STAFF REPORT

PLANNING & ZONING COMMISSION

1. SKETCH PLAN REVIEW

Applicant: Pulte Homes of Ohio LLC
Location: Steitz Road and Hunters Bend
Existing Zoning: Liberty Township Farm Residence District (FR-1)
Proposed Zoning: Planned Residence District (PR)
Request: To approve a Preliminary Development Plan proposed single-family residential subdivision consisting of 183 units on approximately 109 acres.

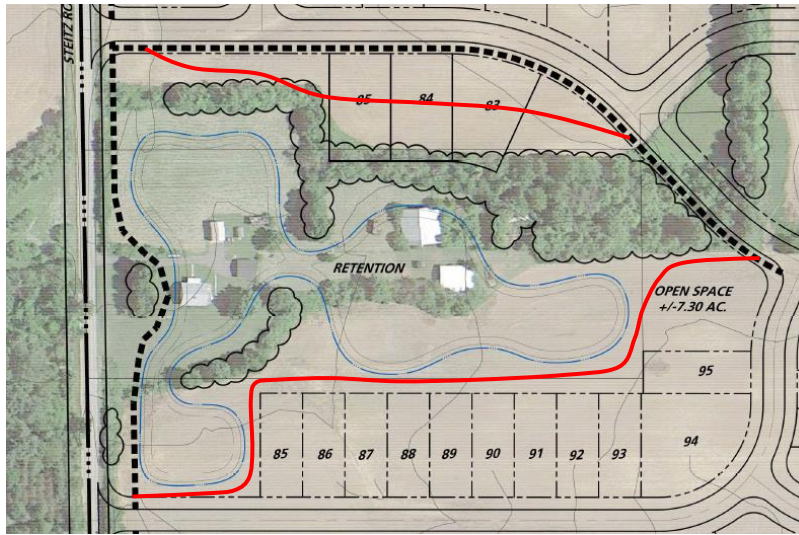
1. Remove lots 83, 84, and 85 from the northern main entrance road. This would increase the amount of open space and takes out lots that seem out of place. Furthermore, it would reduce the density of the project from 1.81 du/ac (dwelling units per acre) to 1.77 du/ac, which is more in line with the 1.7 du/ac maximum that staff feels is appropriate for this area of the city.

2. Have the multi-use paths go through the above open space area instead of at the edges. This would provide a loop trail that residents could use. Also, it improves safety, by taking the trail from the along the road to an interior space. Essentially, separating the pedestrian from the vehicle.
